19 October 2018
File: 14118

Re: **Response to GRCA Comments Dated June 19, 2018**
Proposed Corseed Subdivision (22T-201601)
Corseed Inc.
Town of Grand Valley

**Re: Corseed Draft Plan of Subdivision – 2nd Submission
Part of Lot 30, Concession 2, former Township of East Luther, Town of Grand Valley**

SECTION B-B
 HORIZONTAL SCALE: 1:200
 VERTICAL SCALE: 1:50

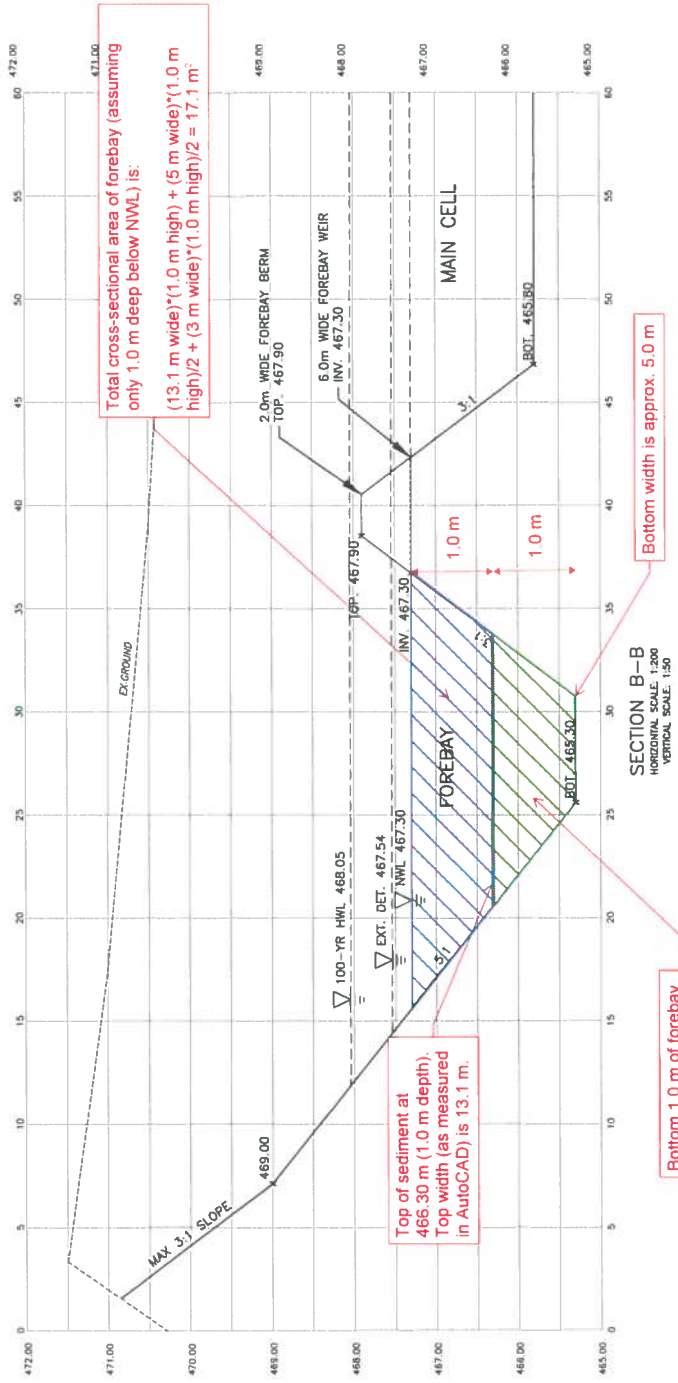
- Comment #6 under the SWM section has not been addressed. We need more clarification regarding the calculations for average velocity in the forebay. Based on the revised report, using the proposed 5m average bottom width, with 3:1 side slopes and a 1m depth (cross-sectional area of ~8 m² vs 17.1 m² referenced in the FSR) we find that average velocity will still be greater than the MOE recommend maximum of 0.15 m/s. Please reconfigure the forebay to ensure that average velocity is minimized when its depth is reduced to its cleanout condition.

We maintain that the forebay cross-sectional area (assuming 1.0 m depth of sediment) is 17.1 m², as indicated in the report. Please find attached a sketch illustrating this.

- The “forebay bottom” width used in the calculation is 13.1 m (as measured in AutoCAD) because we are assuming the bottom 1.0 m is filled with sediment. The 5.0 m bottom width indicated in the comment corresponds to the bottom of the forebay that would be under 1.0 m of sediment.
- The side slopes of the forebay are not the same on both sides (5:1 along the pond perimeter and 3:1 for the forebay berm).
- As shown in the attached sketch, the total cross-sectional area will therefore be 17.1 m².
- Based on a cross-sectional area of 17.1 m², and a 5-year flow of 1.625 m³/s, the average flow velocity through the forebay is 0.095 m/s (17.1 m² ÷ 1.625 m³/s = 0.095 m/s). This is less than the maximum permissible velocity of 0.15 m/s.

Total cross-sectional area of forebay (assuming only 1.0 m deep below NWL) is:
 $(13.1 \text{ m wide}) \times (1.0 \text{ m high}) + (5 \text{ m wide}) \times (1.0 \text{ m high}) / 2 + (3 \text{ m wide}) \times (1.0 \text{ m high}) / 2 = 17.1 \text{ m}^2$

Top of sediment at 469.30 m (1.0 m depth). Top width (as measured in AutoCAD) is 13.1 m.

Bottom width is approx. 5.0 m

Bottom 1.0 m of forebay assumed to be filled with sediment for flow velocity calculations.
